**Chief Scientist
& Engineer**

**Response to questions about advice provided in
the Koala Independent Expert Panel Report
'Advice on the protection of the Campbelltown
Koala population'**

February 2021

Figure 1: Mt Gilead Biobank Koala Corridor with points on Noorumba Reserve (Source: Lendlease)

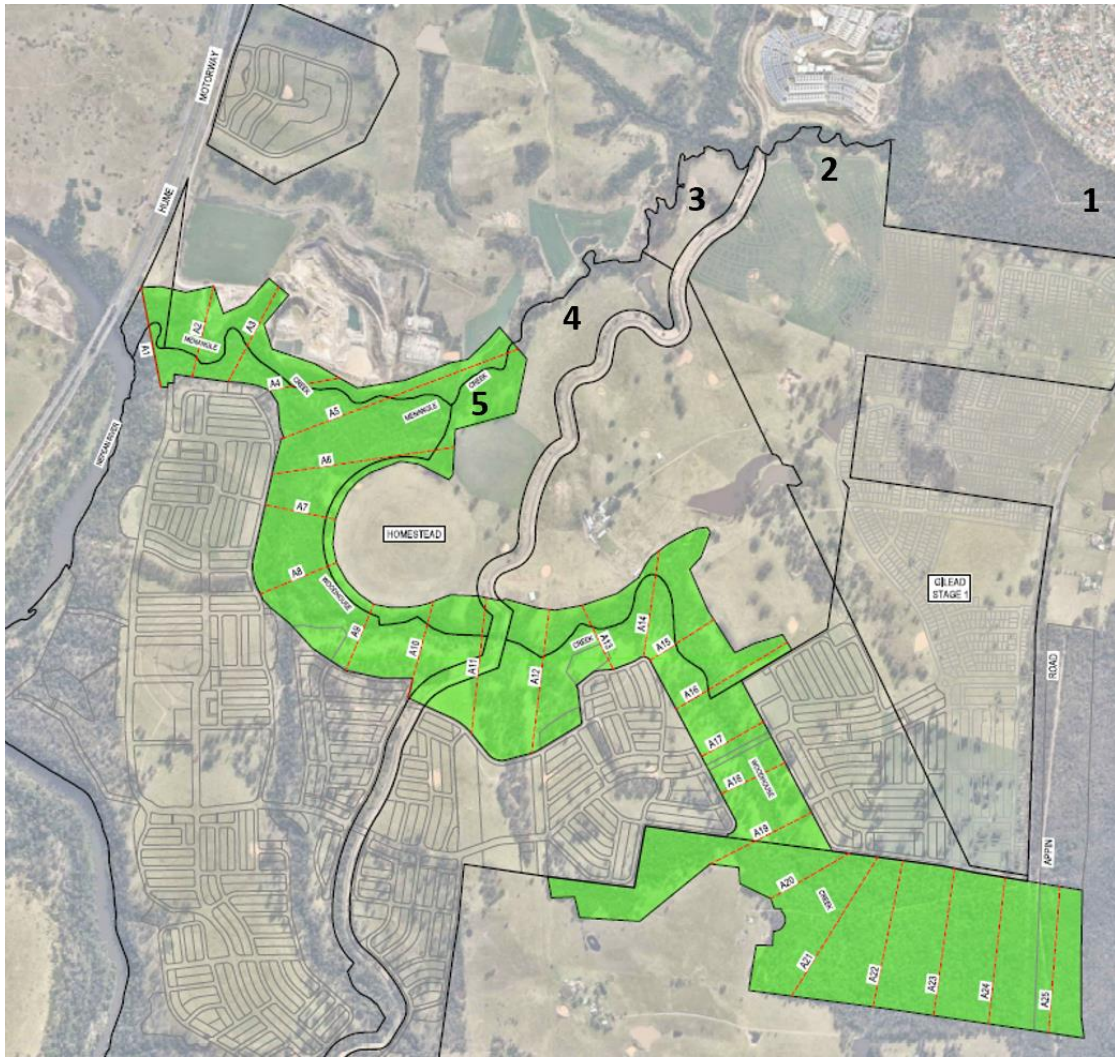
- Noting the connection between Noorumba Reserve and the rest of Corridor A to the west, there is an important strip of vegetation at Point 2 (Figure 1) that extends for approximately 400 m (east-west). If this cannot provide functional connectivity for koalas, Noorumba Reserve effectively becomes a 'dead end'; therefore, efforts should be made to ensure that this habitat functions as connectivity.

- The Upper Canal (between Point 2 and 3, Figure 1) could also prevent the east-west movement under the proposed development. The Panel did not see the topography at this point; therefore field inspections should be undertaken to understand the impact on the corridor and associated habitat, and the impact on koala movement.

- The Panel notes that the Mount Gilead Homestead was gazetted as Heritage Listed by the NSW Government (14 October 2020). This will protect the 150 ha homestead from any further development that is not sympathetic to the heritage listing, which will also indirectly benefit adjacent koala habitat including Corridor A at Points 4 and 5 on Figure 1.

- *Land holdings north and east of Menangle Creek*
 - At Point 5 in Figure 1 is the confluence of Menangle and Woodhouse Creeks. The area north and east of this point (i.e. prior the confluence of the creeks) would be considered part of Corridor A – contributing to its length. Therefore, this should not be included in the calculation of Corridor B as a width component.

Figure 3: Mt Gilead Biobank Koala Corridor showing measurement lines (source Lendlease)

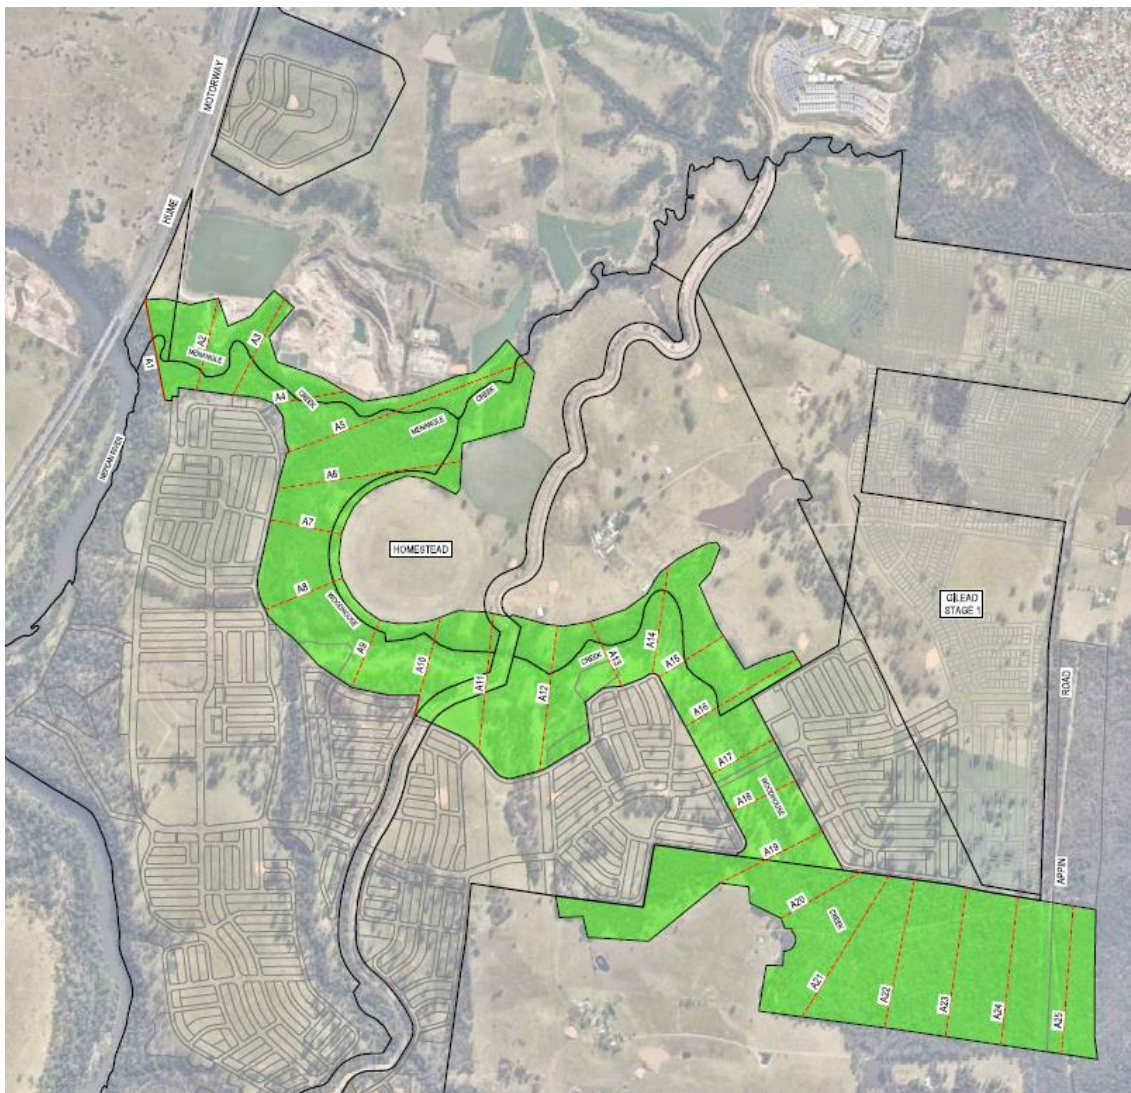
- Based on the Figure provided by Lendlease, the Panel does not understand how this methodology of Dr Phillips was applied by the proponent which is purported to be in accordance. For example, there is no consistency in the application of the 200 m intervals between the transects along the length. For example, the distance between A8 to A9 is much greater than the distance between A17 to A18.

- Further, there are irregularities in the orientation of the transects: for example, A4 is at an unusual angle to the other measures, and to the corridor (i.e. oblique, rather than perpendicular), and this is noted for a number of the other transects.

- Dr Phillips' calculation methodology requires a "...series of width measurements...each of which must evidence the minimum width requirement of 250 m...". It appears to the Panel that

rather than drawing 90 degree cross sections that demonstrate a minimum corridor width of 250 m, as is understood as the intent in Dr Phillips approach, instead lines appear to have been drawn at random angles to meet the minimum width requirement of 250 m (this may explain the orientation of the A4 transect). The Panel would expect the transects to measure corridor width to be perpendicular to the length of the corridor.

- The Panel views that the transects as drawn do not provide a realistic reflection of the actual corridor width, as there is no consistency in the distance between and angles of the transects, and the potential interaction between Corridors A and B (transects A5 and A6).
- Therefore, the Panel recommends that the Proponent should provide a clearly articulated, transparent and defensible method for calculating the corridor widths and the orientation of the transects.
- The Panel also notes the clarification sought in Question 4 regarding average corridor width and buffer to the corridor, this should be considered in the calculations.

Figure 4: Steep topography associated with the Nepean River Corridor (Sources: Lendlease and overlay from SEED Portal¹⁸)

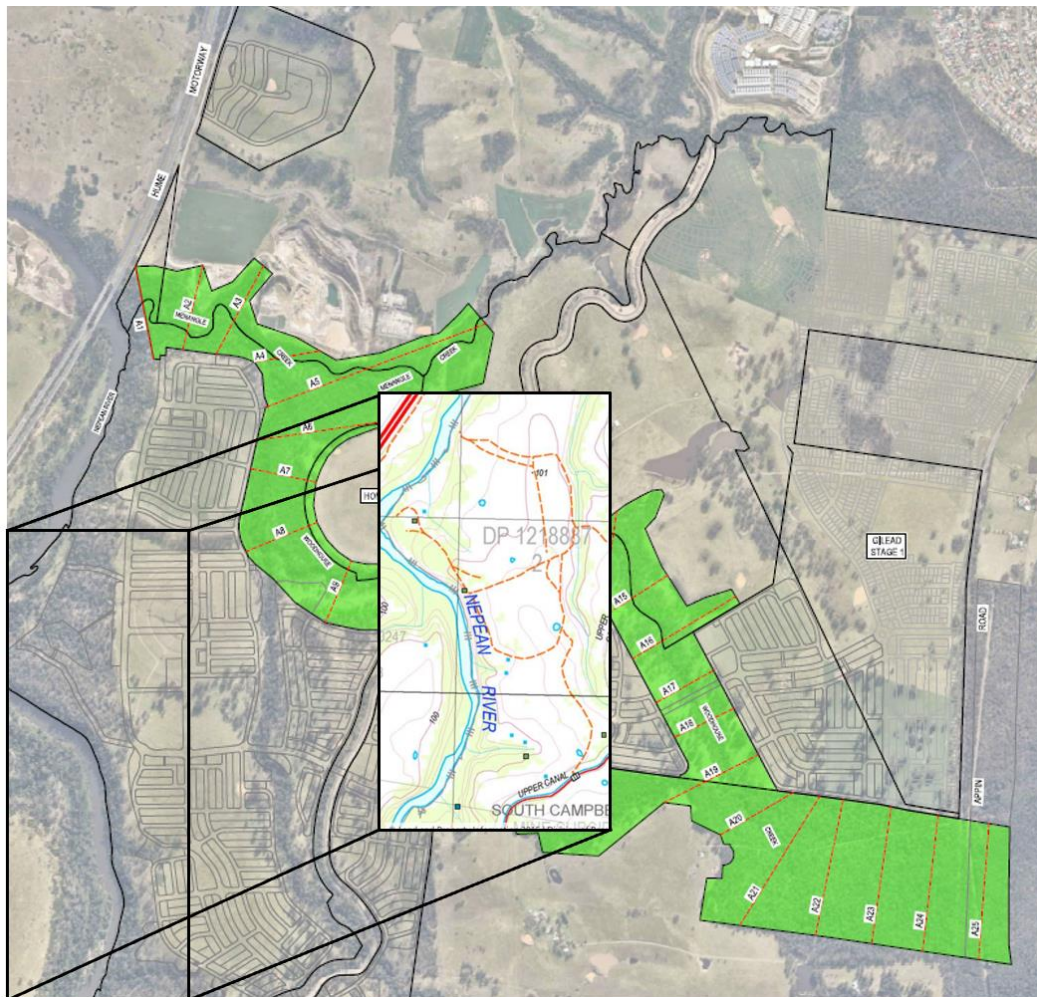
- Therefore, they should be treated as separate corridors that provide a symbiotic-like protection to the adjacent riverbank.
- The area highlighted in Figure 4 should be examined on the ground (field trip inspection) to ensure that the amount (width and density) and structure of the habitat and terrain will facilitate a functional corridor given distance to roads and suburban footprint that is evident on the map in Figure 4.

- The Panel also notes the potential for steep topography in the riparian zone and associated koala habitat (Figure). There is a need to understand this topography, and how the current koala population moves through the landscape, including if the koalas have a preference for moving long the steep river bank or whether they use the plateau (where the suburban footprint is planned), which will inform any additional protections. This is also important when considering the risk of fire. These issues should be addressed in the planning phase but prior to approval.

Figure 2: With exclusion fencing

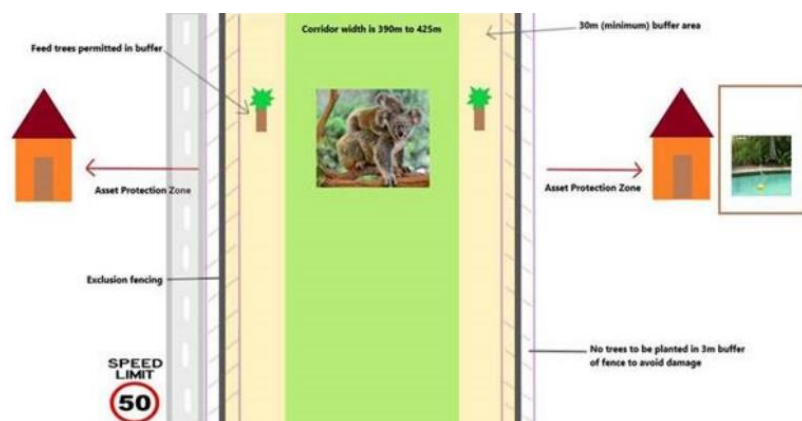
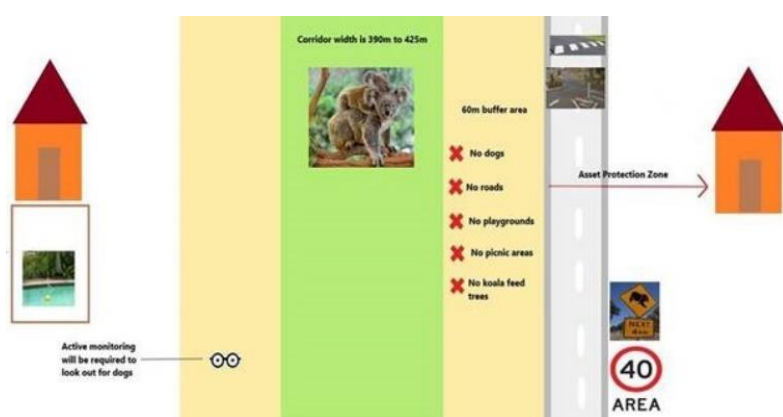
EES has interpreted the OCSE requirement for corridors, buffers and exclusion fencing as detailed in the EES prepared diagrams below.

For context, the proponent has queried whether APZ (outer protection areas) should be permitted within the corridors and buffers to allow for areas of reduced fuel load/ flame intensity as refuge for fauna. (refer to “Attachment – proponent cross section”)

Could we please confirm the OCSE’s intention in regard to Recommendation 2 c) and whether EES’s interpretation, as illustrated in the diagrams above, is accurate?

- The Homestead's 'Retained' land, while acting as a buffer, should not be included in corridor calculations.
- Figure 8(A-C) provides a visual guide from the Panel in response to DPIE's interpretation (Figure 2 and Figure 3), with Table 1 providing a summary of activities allowed in the buffer zones.

Figure 4: Example of buffer zone at proposed Mount Gilead Stage 2 development (Source: Eco Logical Australia, 2020)

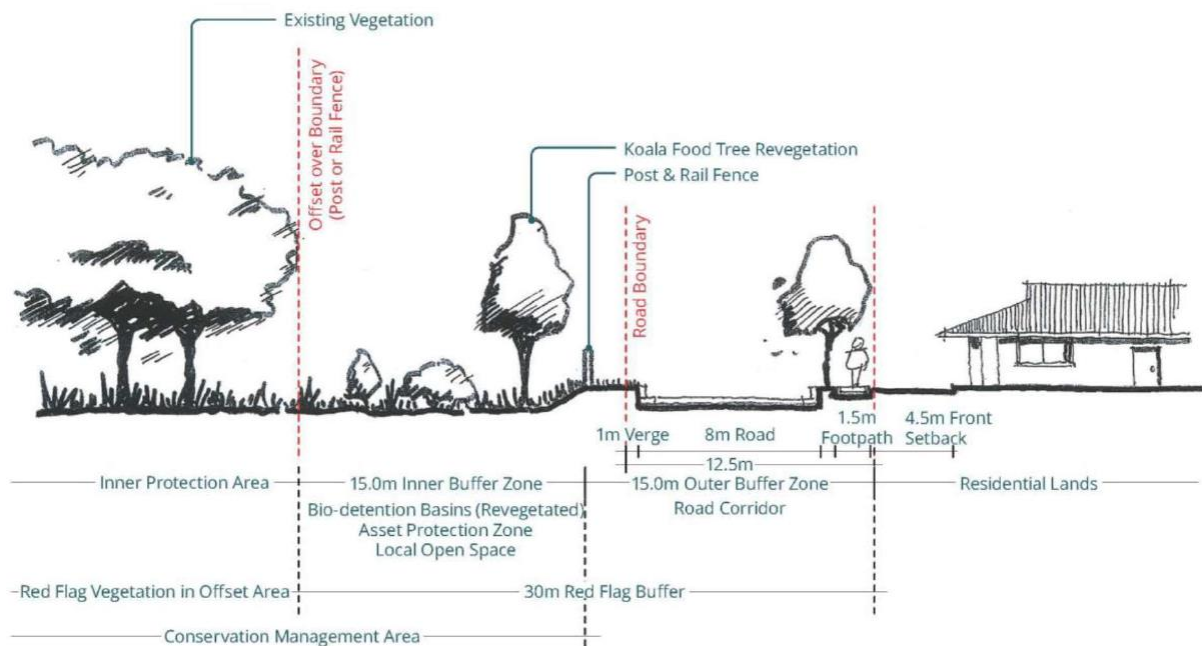
- The Panel saw the design as ineffective as it permitted threatening activities in close proximity to koalas and koala habitat with no barrier to interaction between koalas and hazards.
- Further, the Panel's site visit allowed them to see the current habitat and assisted in their advice (Figure 6). In particular, this site visit showed the Panel the topography of the creek lines and the sparseness of the remaining vegetation (as you can see through the remaining habitat). As the habitat stands, it would not provide adequate protection to koalas and their habitat from the development, including in regard to light and sound penetration. Therefore, the recommendations that were made in the Panel's Report reflect the on-ground assessment and the need to improve and protect the koala corridor habitat.

- Figure 9 provides a view of the Panel's thinking in response to Figure 6 – the Asset Protection Zone should be outside of the exclusion fencing, and the 'Inner Buffer Zone' should be doubled from 15m in Figure 6 to 30 m in Figure 9.
